November 7, 2023

**Subject: The Reserve at Miscoe Hills
Comprehensive Permit Plan Review**

- Plans entitled The Reserve at Miscoe Hills, Comprehensive Permit Plan, 116 Upton Street, Grafton, Massachusetts dated May 17, 2023 and revised October 25, 2023, prepared by Turning Point Engineering for Upton Road Properties, LLC. (26 sheets)

SHEET NO.
C-5.1

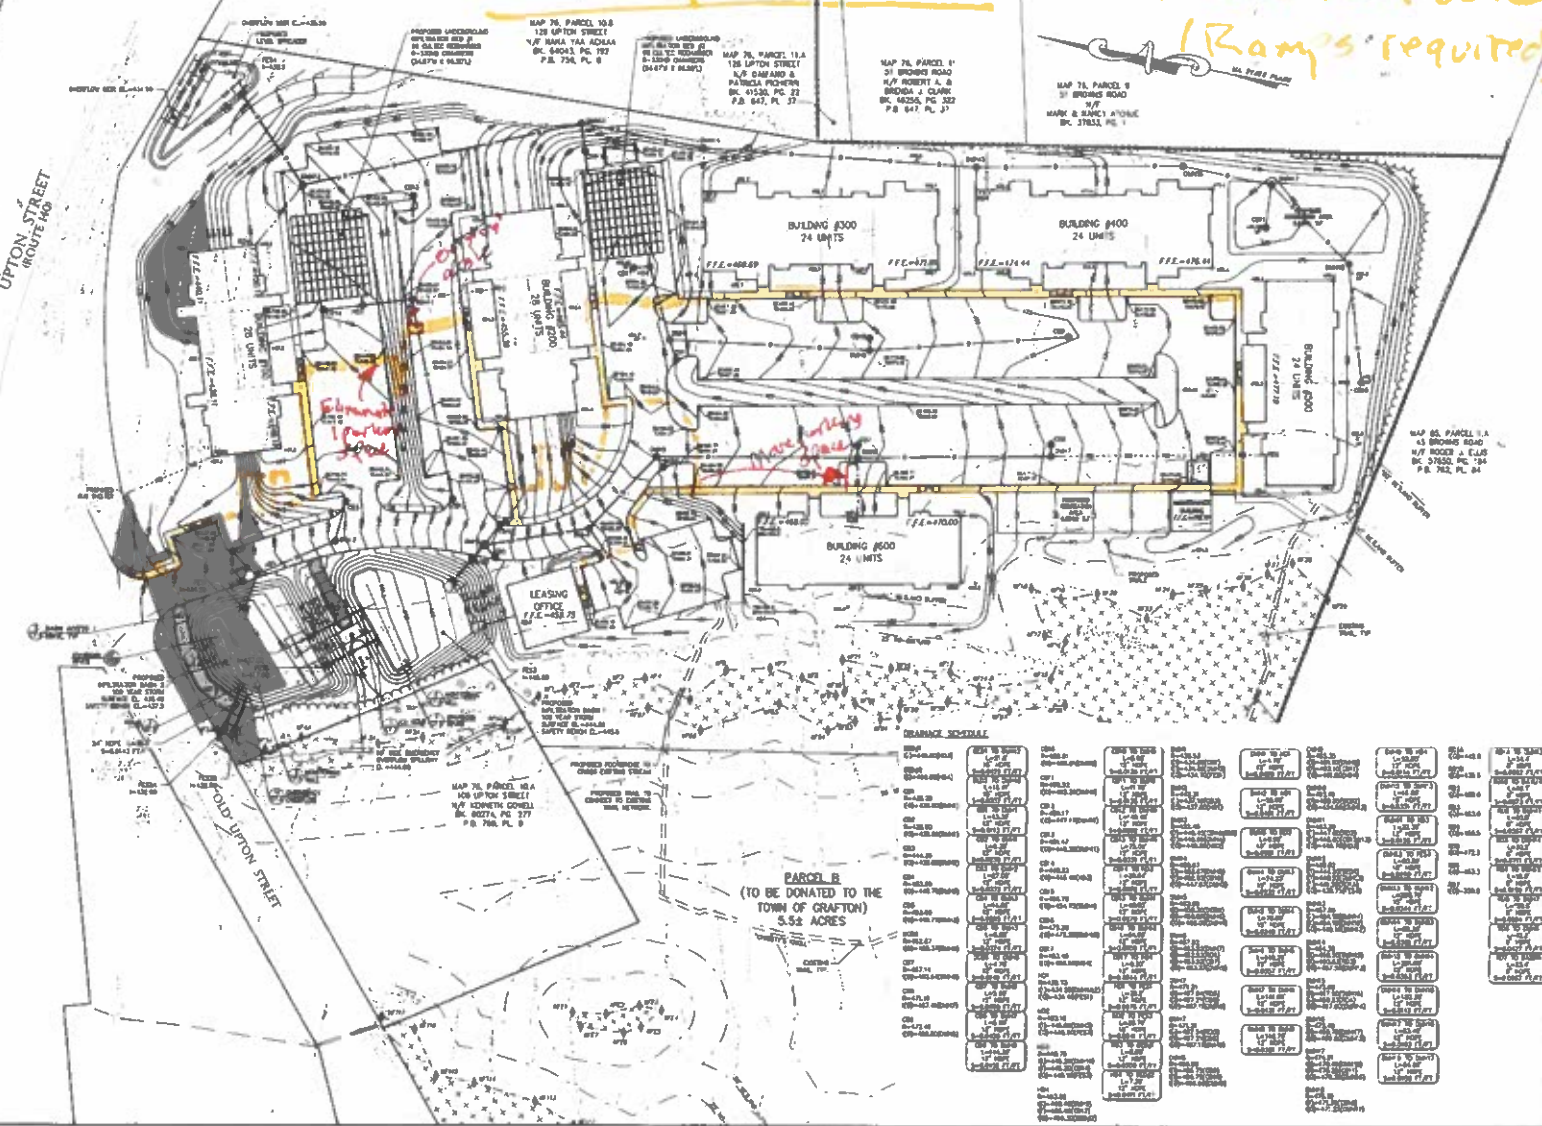
27. Because of grades that exceed a maximum of 5.0% for a walkway (521 CMR 22.00 – Architectural Access Board), the plans do not propose an accessible route between the driveway entrance at Old Upton Street and the developed portion of the site. GEI understands that the applicant may be considering an application for a variance from the Massachusetts Architectural Access Board. Such a variance application would require the applicant to demonstrate that full compliance with 521 CMR is *impracticable* as defined in 521 CMR. In GEI's opinion, the applicant should consider adding ramps where necessary to address grades that exceed 5.0%. (Ramps are already proposed in front of Buildings #300, #400, #600 and between Building #600 and the leasing office.) GEI prepared the attached concept sketch of an accessible route from the driveway entrance to the developed portion of the site and to each building therein. Implementing the concept would require adding three sets of ramps, eliminating one parking space, and eliminating or relocating another parking space.

Concept Sketch

Potential
Accessible Route
(Ramps required)
